Attachment D

APPLICATION NO.	FILING DATE	FIRST NAMED INVENTOR	ATTORNEY DOCKET NO.	CONFIRMATION NO.
10/720,821	11/24/2003	Douglas B. Wilson	114089.120	5355
23483	7590	11/20/2009		
WILMERHALE/BOSTON			EXAMINER	
60 STATE STREET			JJONG, VINH	
BOSTON, MA 02109			ART UNIT	PAPER NUMBER
			3656	
			NOTIFICATION DATE	DELIVERY MODE
			11/20/2009	ELECTRONIC

Office Action Summary	Application No.	Applicant(s)	
	10/720,821	WILSON, DOUGLAS B.	
	Examiner Vinh T. Luong	Art Unit 3656

APPENDIX - I

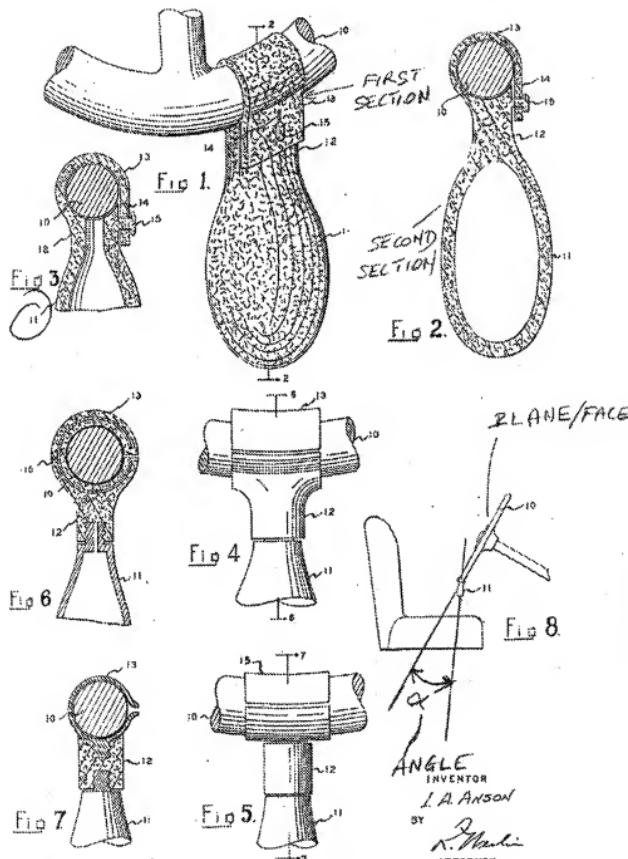
a first section 13 that connects to a peripheral portion of the steering wheel 10; a second section 11 extends from the first section at the peripheral portion of the steering wheel 10, the second section 11 extends from the first section 13 outward at an angle (α in Fig. 8 of Appendix 1 hereinafter "App. 1") to a plane (App. 1) across a face (App. 1) to the steering wheel 3, the second section 11 being capable of providing resting support for at least a portion (e.g., the hand) of a vehicular operator's body when pressure from the portion of the vehicular operator's body on the second section 11 is less than the pressure for deforming the second section 11 out of interference with the vehicular operator's ability to operate the steering wheel 10, and deforming out of interference with the vehicular operator's ability to operate the steering wheel 10 when pressure from the portion of the vehicular operator's body on the second section 11 is equal to or greater than the pressure for deforming the second section 11 out of interference with the vehicular operator's ability to operate the steering wheel 10. Anson, p. 1, left col., l. 6 - right col., l. 53.

APPENDIX 2
FIG. 1 OFF 2

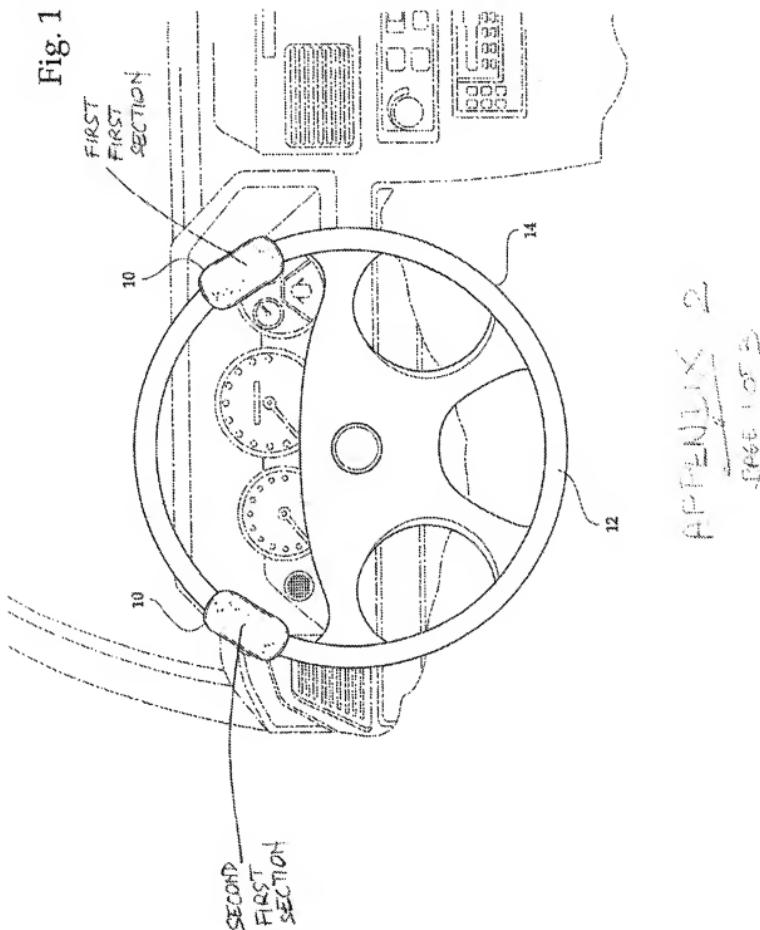
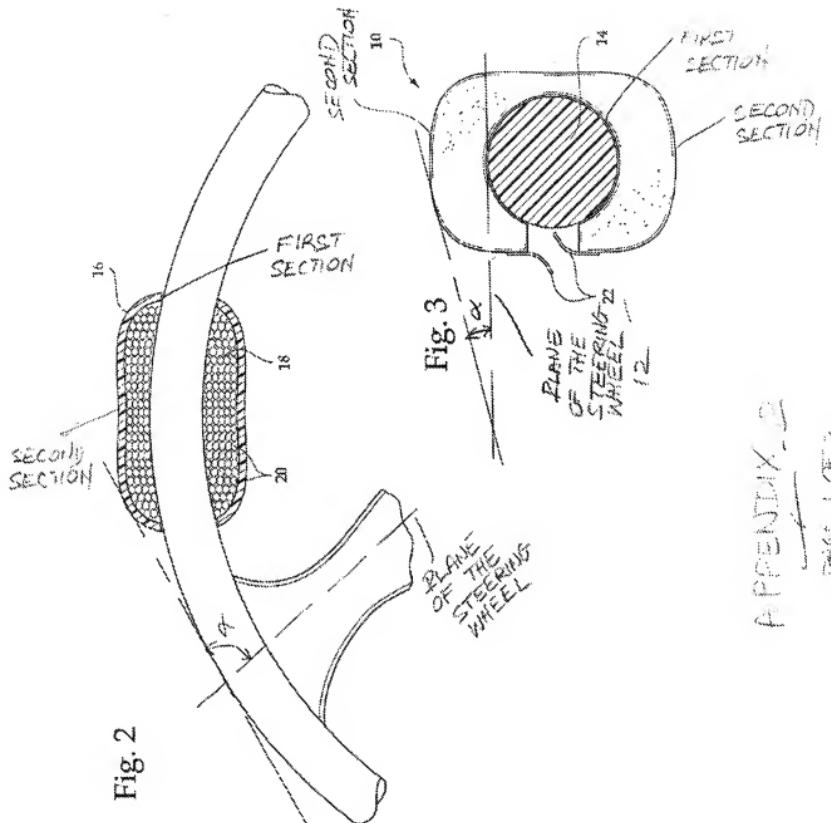
Alternatively, Gemma teaches at least two deformable first sections (*i.e.*, the first first section and the second first section connected to the rim/peripheral portion 14 of the steering wheel 12, see Appendix 2 hereinafter “App. 2” and Gemma, ¶¶ 24-26) and at least two second sections (*i.e.*, the first second section 16, 26 and the second second section 16, 26 squeezed by the vehicle operator) in order to relieve fatigue to the vehicle operator. Gemma, Summary of the Invention.

at least a first first section (FIG. 1) and a second first section (FIG. 1) that connect to a peripheral portion/rim of the steering wheel 12 (Gemma, ¶ 26); and

at least a first second section 16, 26 (FIG. 1) and a second second section 16, 26 (FIG. 1) that connect to, and extends from the first and second first sections (FIG. 1), respectively, with the first and second second sections 16, 26 extending from the respective first and second first sections outward at an angle (α in FIGS. 2 and 3 of App. 2) to a plane (App. 2) across a fact to the steering wheel 12, the first and second second sections 16, 26 each providing resting support for at least a portion of a vehicular operator's body when pressure from the portion of the vehicular operator's body on the first or second second section 16, 26 is less than the pressure for deforming the first or second second section 16, 26 out of interference with the vehicular operator's ability to operate the steering wheel 12, and deforming out of interference with the vehicular operator's ability to operate the steering wheel 16, 26 when pressure from the portion of the vehicular operator's body on the first or second second section 16, 26 is equal to or greater than the pressure for deforming the first or second second section 16, 26 out of interference with the vehicular operator's ability to operate the steering wheel 12.

APPENDIX 2
PAGE 1 OF 3

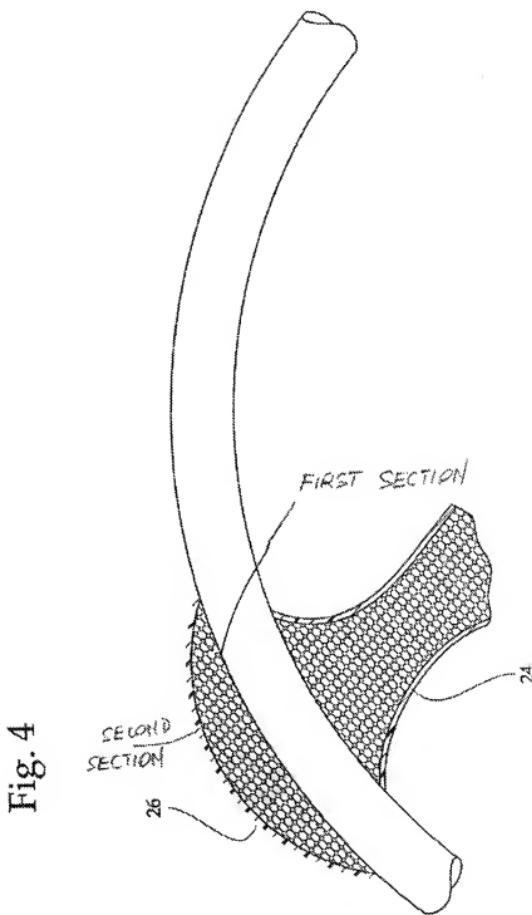
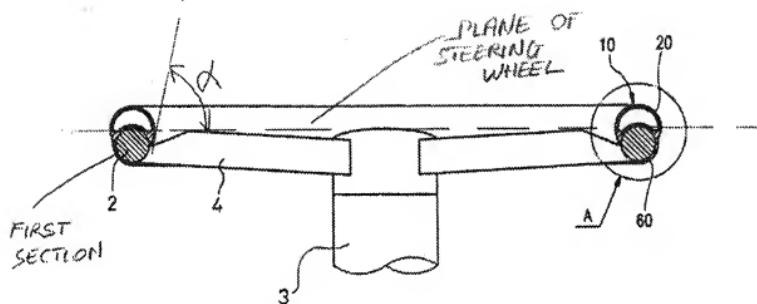
a second section 16, 26 extends from the first section (App. 2) at the peripheral portion of the steering wheel 12, the second section 16, 26 extends from the first section (App. 2) outward at an angle (α in FIGS. 2 and 3 of App. 2) to a plane (App. 2) across a face (Att. 2) to the steering wheel 12, the second section 16, 26 being capable of providing resting support for at least a portion (e.g., the hand) of a vehicular operator's body when pressure from the portion of the vehicular operator's body on the second section 16, 26 is less than the pressure for deforming the second section 16, 26 out of interference with the vehicular operator's ability to operate the steering wheel 12, and deforming out of interference with the vehicular operator's ability to operate the steering wheel 12 when pressure from the portion of the vehicular operator's body on the second section 16, 26 is equal to or greater than the pressure for deforming the second section 16, 26 out of interference with the vehicular operator's ability to operate the steering wheel 12.

APPENDIX - 3
11

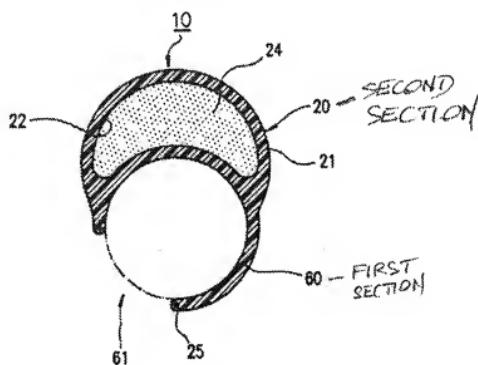
11. Claim 20 is rejected under 35 U.S.C. 102(b) as being anticipated by Park (US 5,207,713).
Park teaches a fatigue relieving/preventing apparatus 10 associated with a steering wheel 1 for controlling a vehicle comprising:
 - a first section 60 (see, e.g., FIGS. 1-7 and c. 2, ll. 53-62) that connects to a peripheral portion 2 of the steering wheel 1;
 - a second section 20 extends from the first section 60 at the peripheral portion 2 of the steering wheel 1, the second section 20 extends from the first section 60 outward at an angle

(see, e.g., angle α in Fig. 2A of Appendix 3 hereinafter “App. 3”) to a plane (App. 3) across a face (App. 3) to the steering wheel 1, the second section 20 being capable of providing resting support for at least a portion (e.g., the hand) of a vehicular operator’s body when pressure from the portion of the vehicular operator’s body on the second section 20 is less than the pressure for deforming the second section 20 out of interference with the vehicular operator’s ability to operate the steering wheel 1, and deforming out of interference with the vehicular operator’s ability to operate the steering wheel 1 when pressure from the portion of the vehicular operator’s body on the second section 20 is equal to or greater than the pressure for deforming the second section 20 out of interference with the vehicular operator’s ability to operate the steering wheel 1.
